Powerfuel Portland Ltd

Schedule 5 Response No 1

Figure 14
Domain Surface Roughness Length

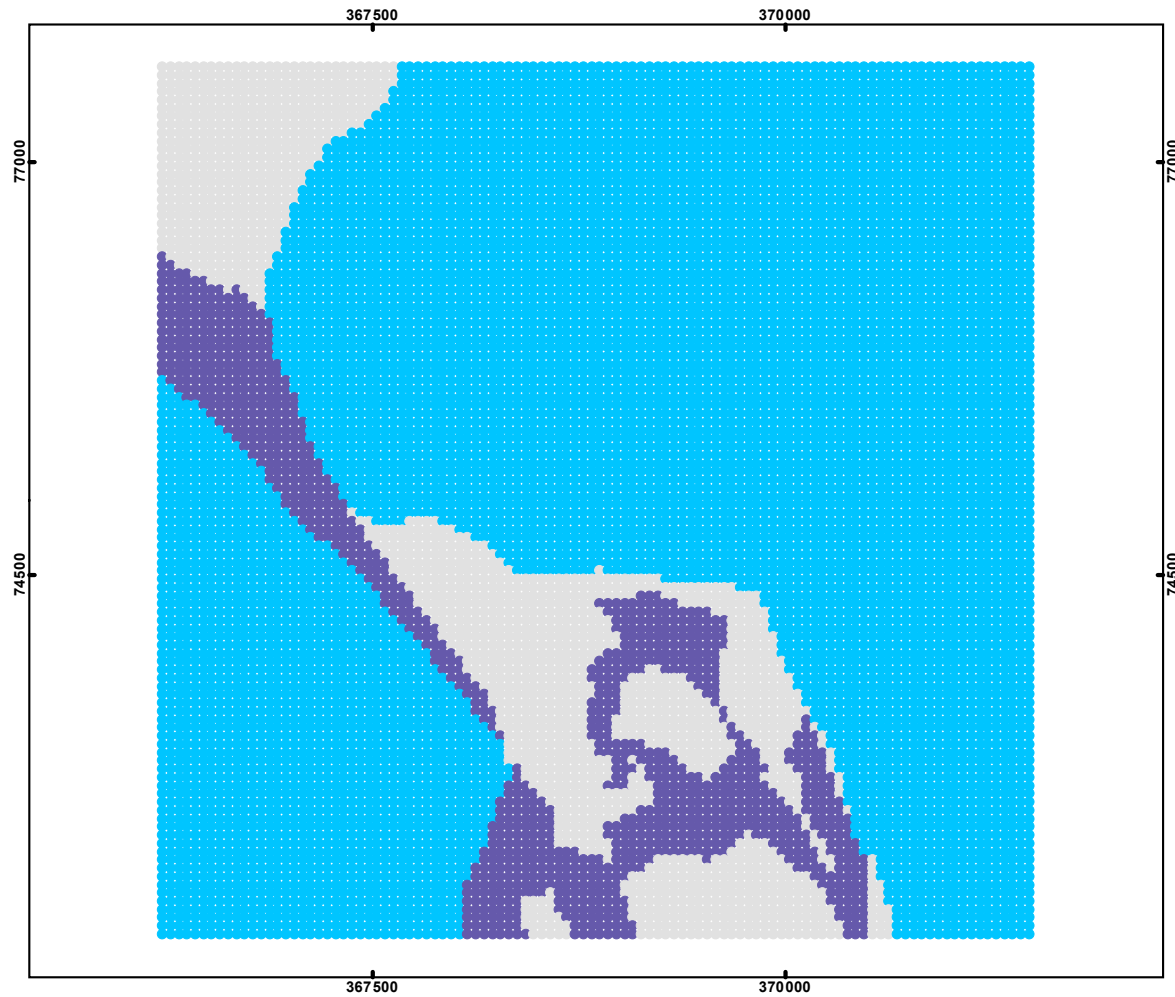
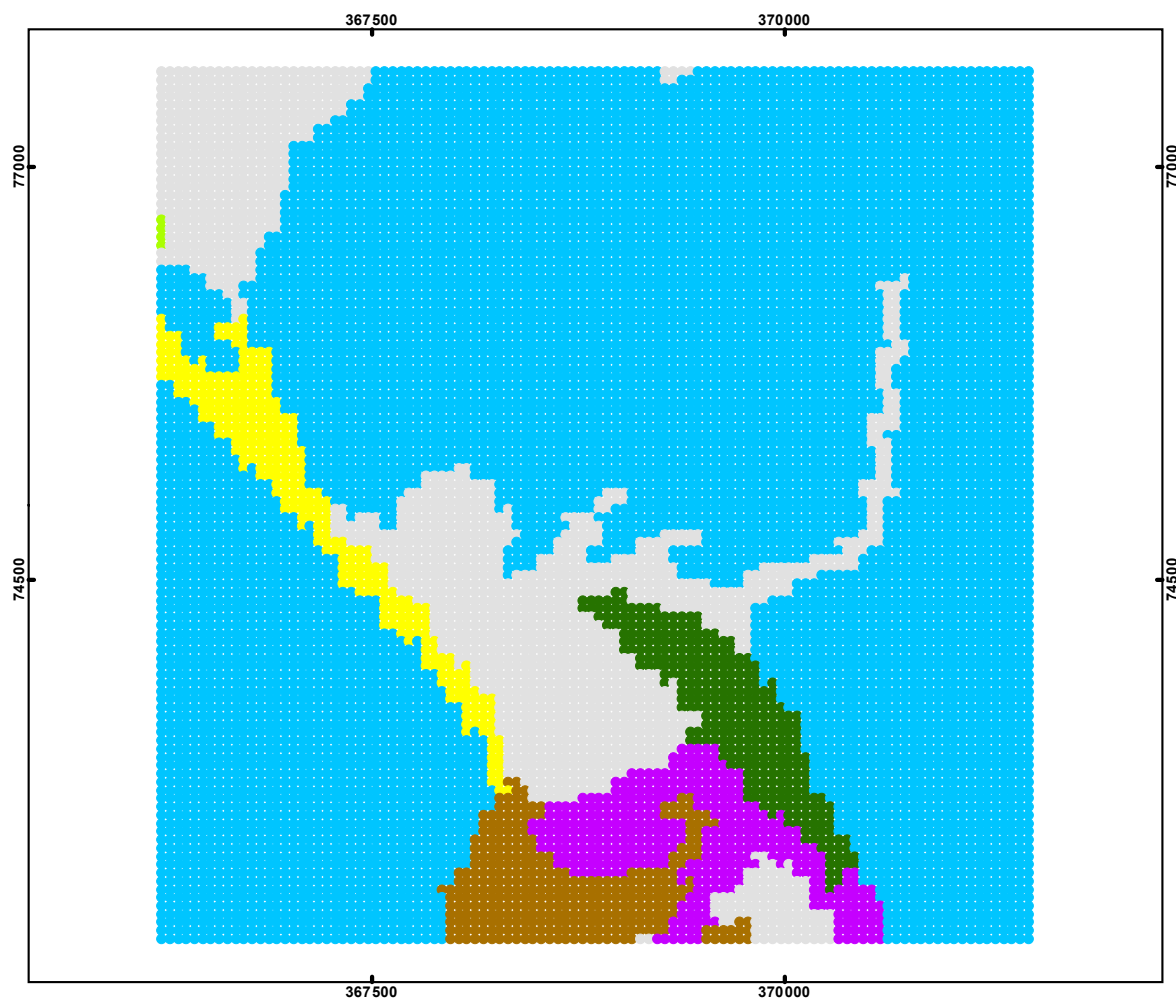
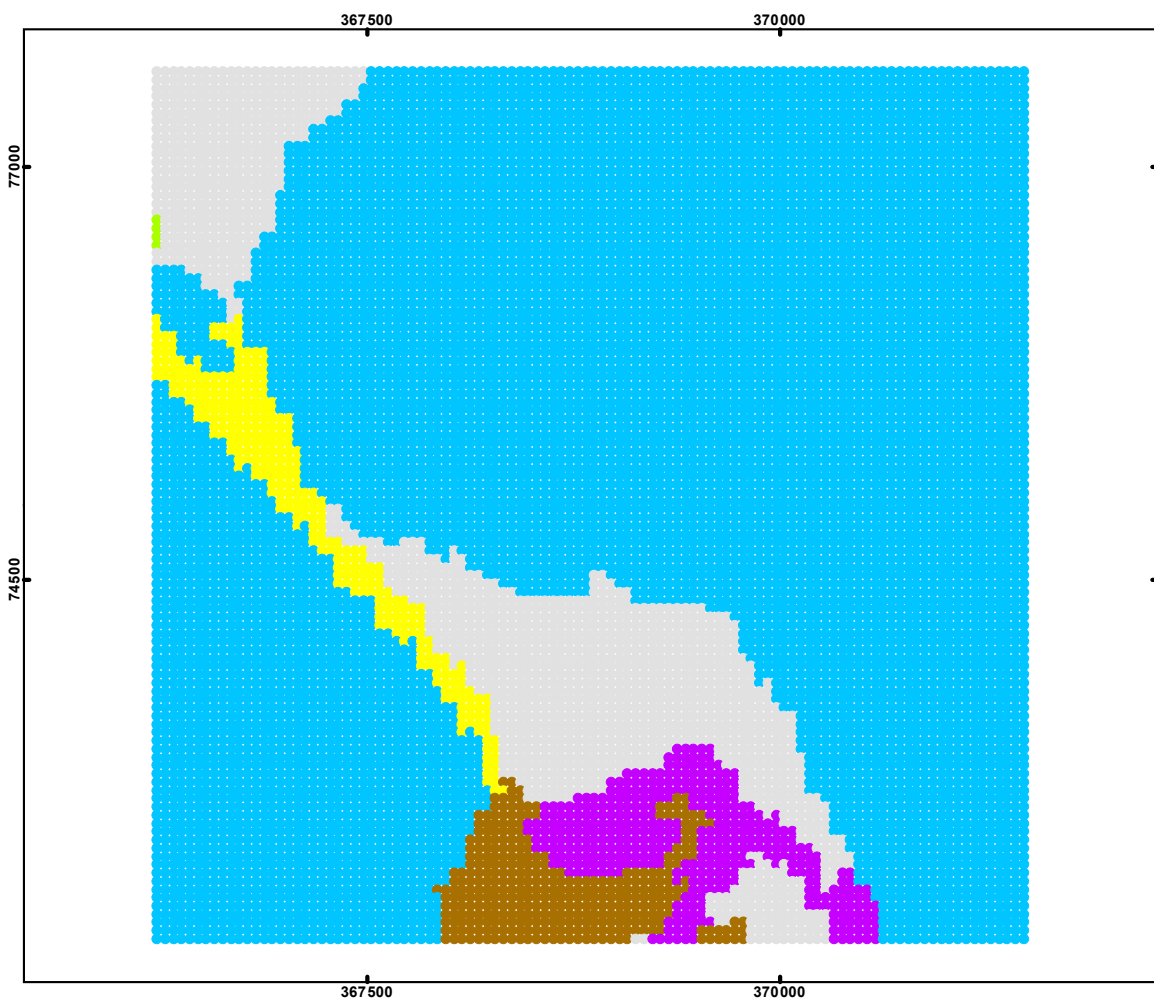
The CORINE Land Cover database has allocated the hillside to the west of the Portland ERF to be code 311 ("broadleaved forest") and the recommended surface roughness value is 0.75 m. However, this area is actually scrub habitat and it is considered that a surface roughness value of 0.5 is more appropriate, albeit still on the high side. As such, a modified variable surface roughness file, reducing the surface roughness of the land to the west of the Portland ERF to 0.5 m, has also been generated. A visualisation of this modified surface roughness file is provided in Figure 14 contained in Appendix A.

Figure 21
Meteorological Observation Stations

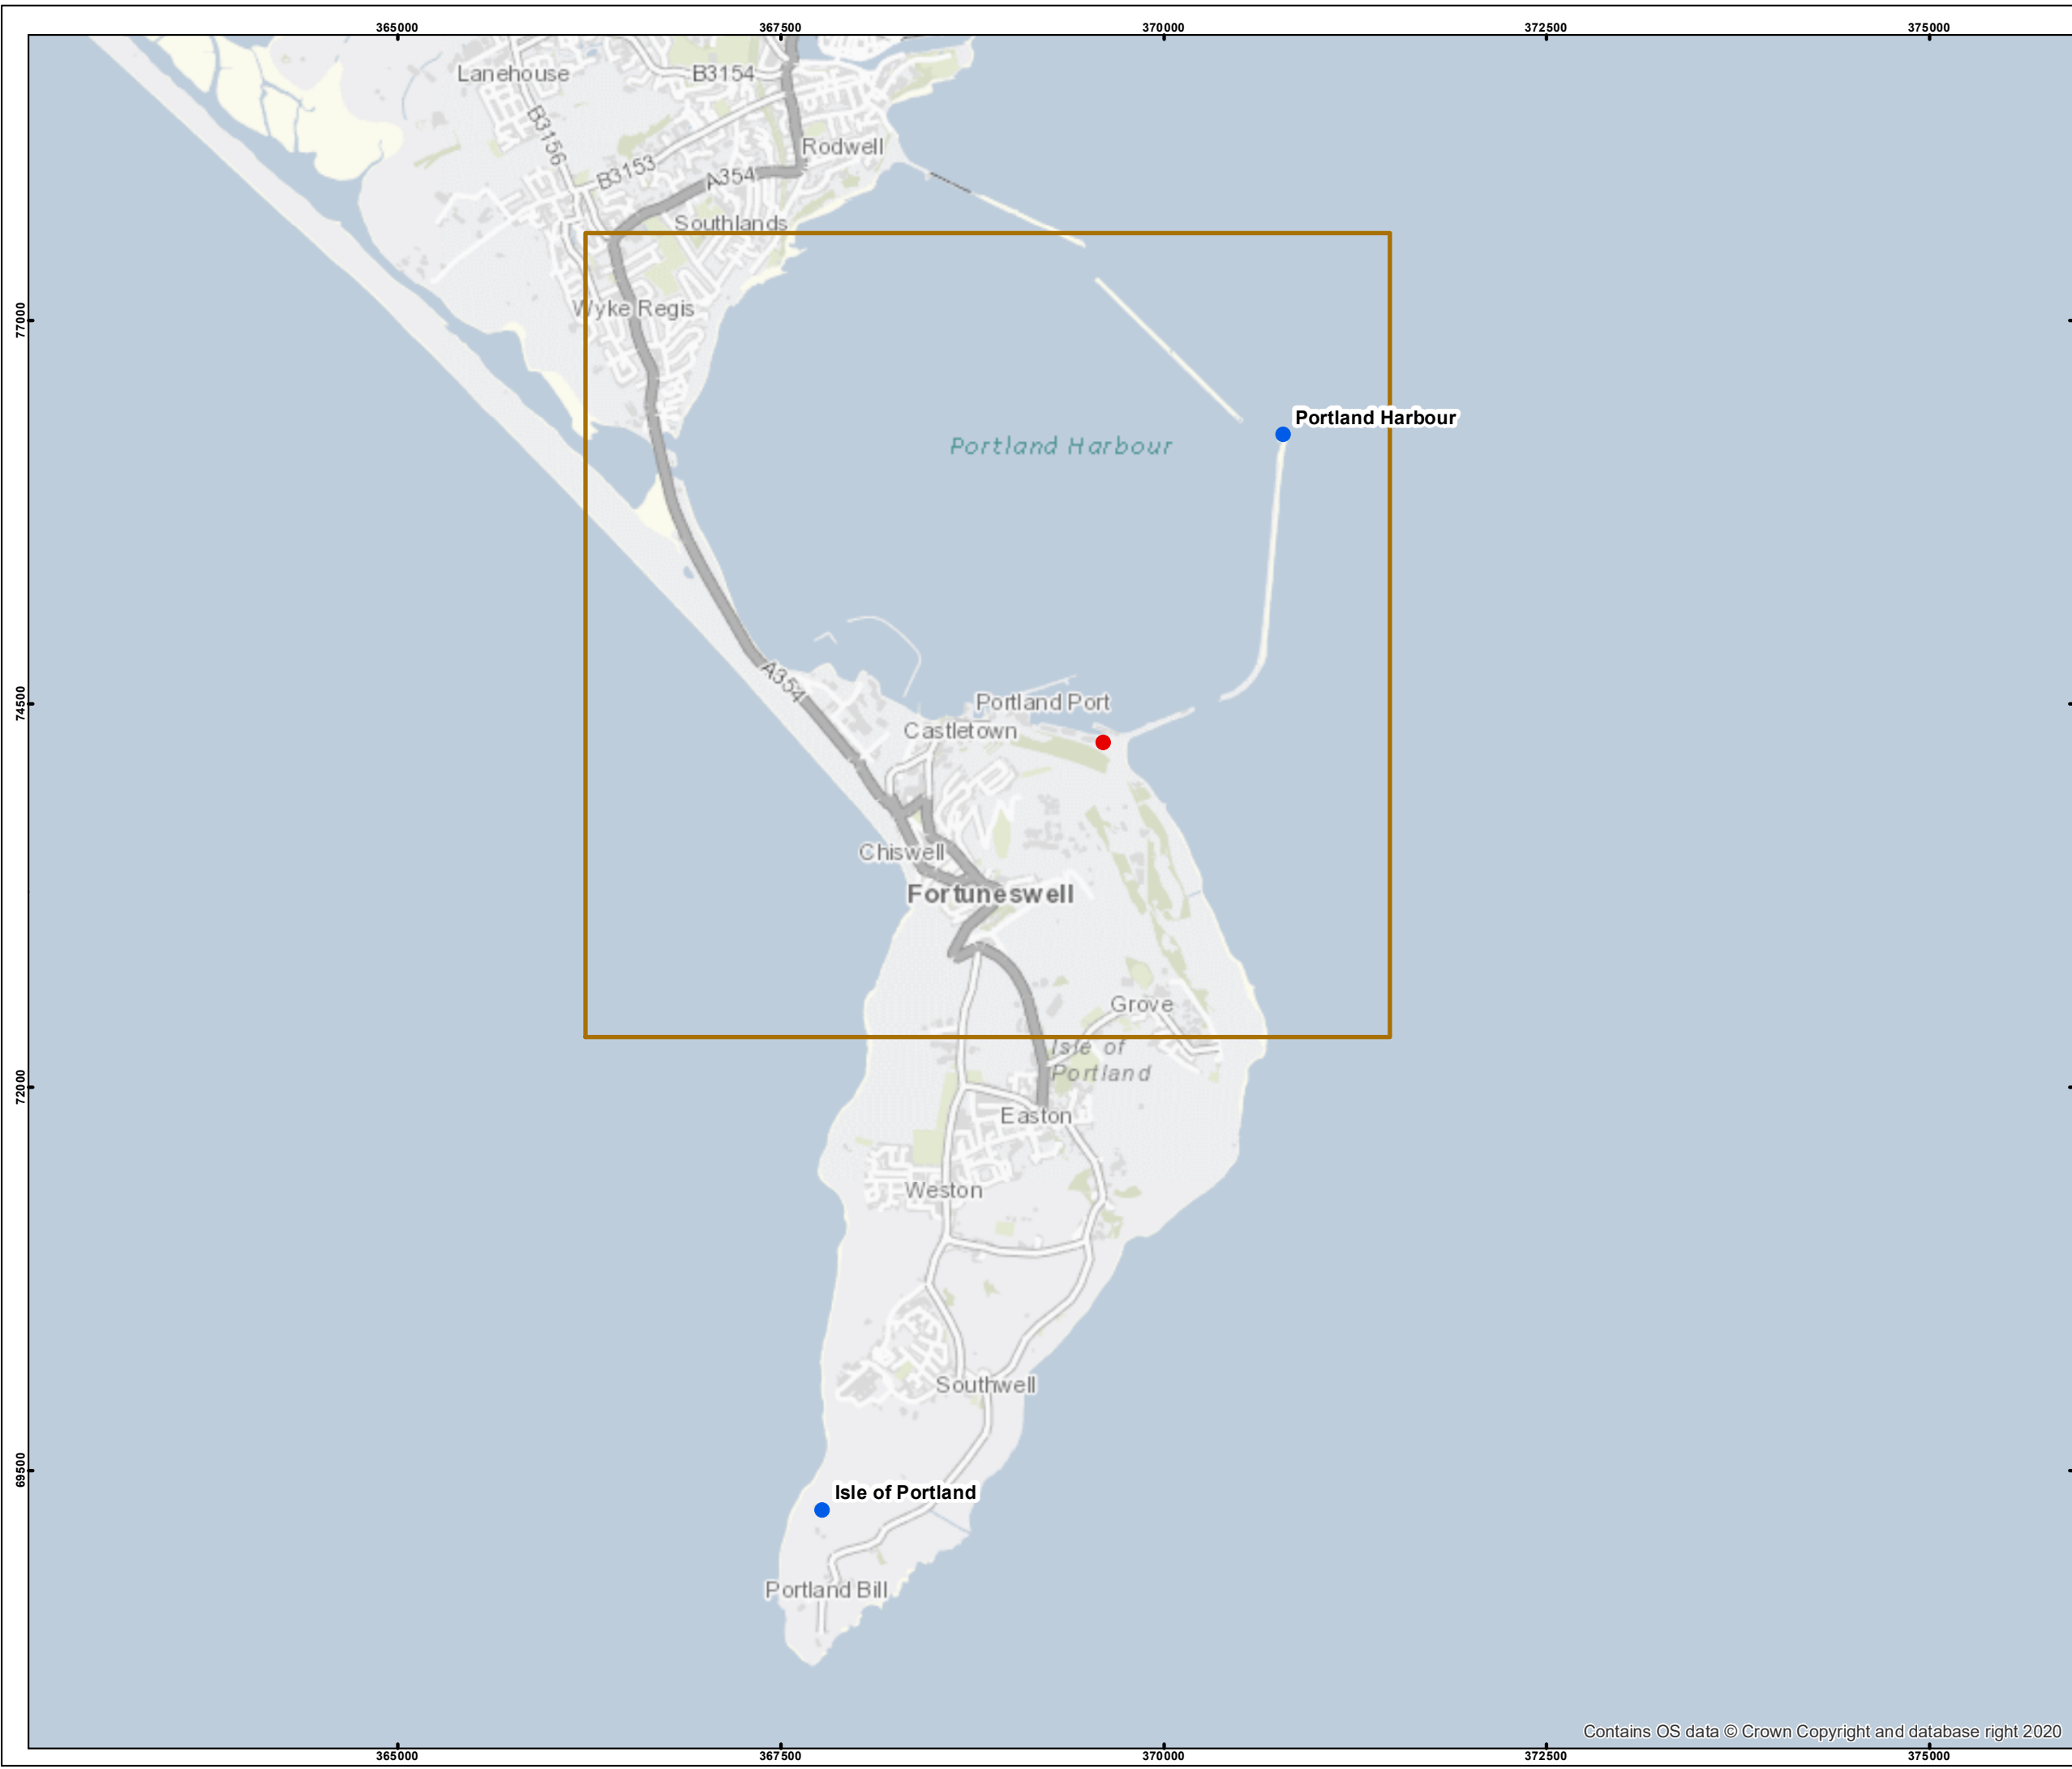
located in a similar setting to the dispersion site, monitors all of the data needed for a dispersion model, and has a high level of data capture. The location of the meteorological observation site is presented on Figure 21 contained in Appendix A.

Figure 24
Wind Data Comparison

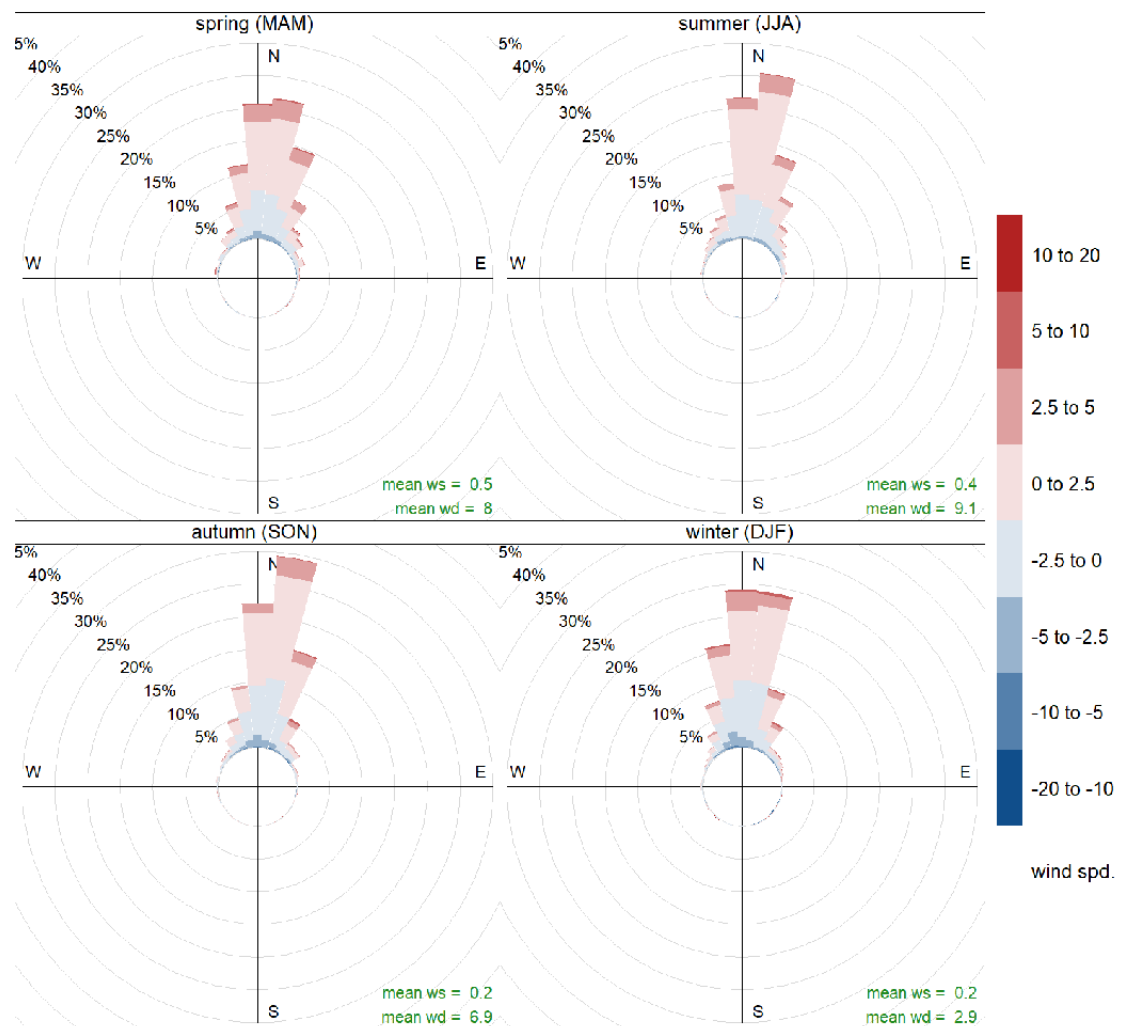
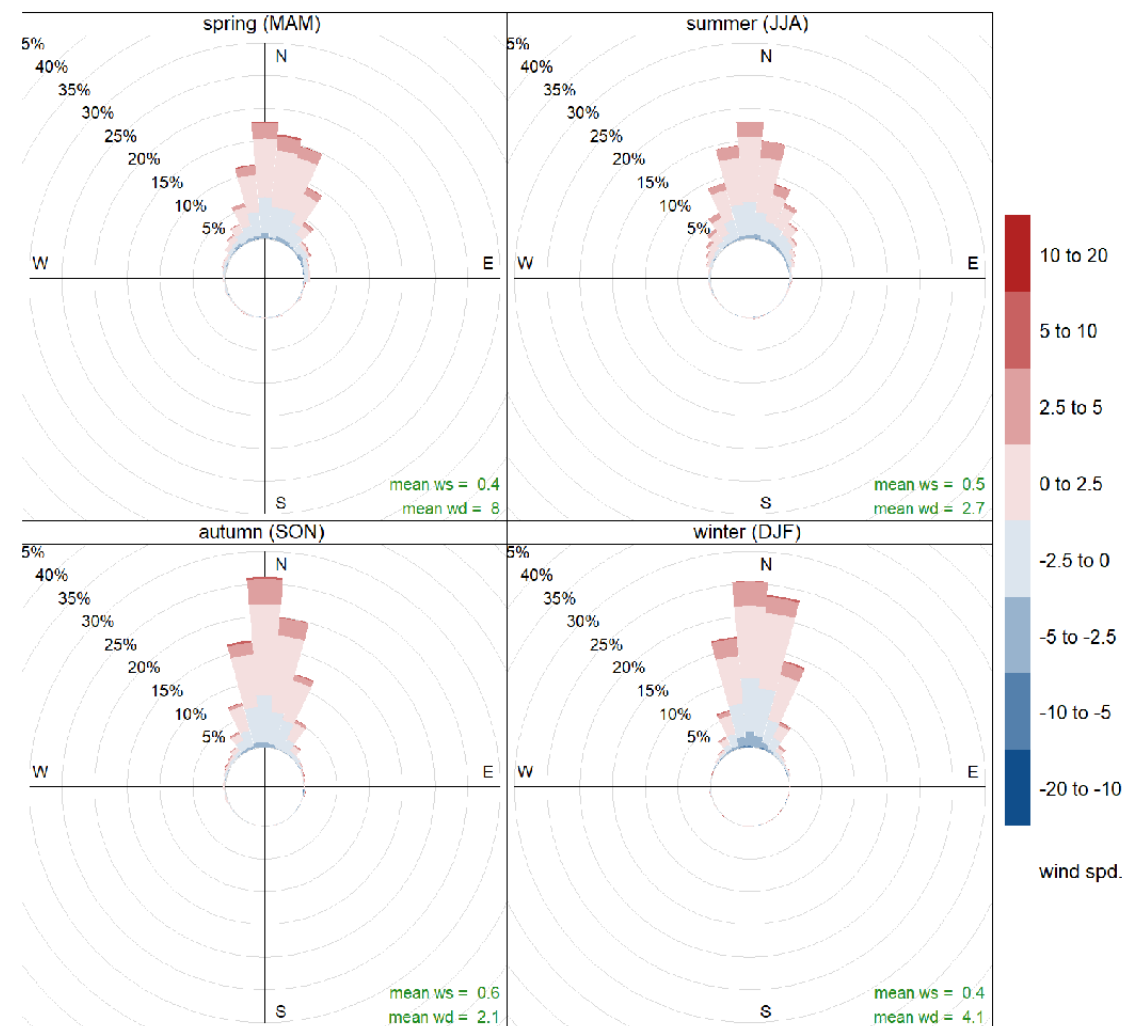
The OpenAir package¹⁰ has been used to analyse if there is any bias in the wind speed and direction in the Portland Harbour data compared to the Isle of Portland data as used in the DMA. The results are presented as a wind rose, with an angle of 0° (shown as pointing north) meaning no bias and an angle of 30° meaning that the Portland Harbour data for that hour is 30° greater than the Isle of Portland dataset. This is shown in Figure 24 contained in Appendix A. This confirms that the datasets are broadly similar.
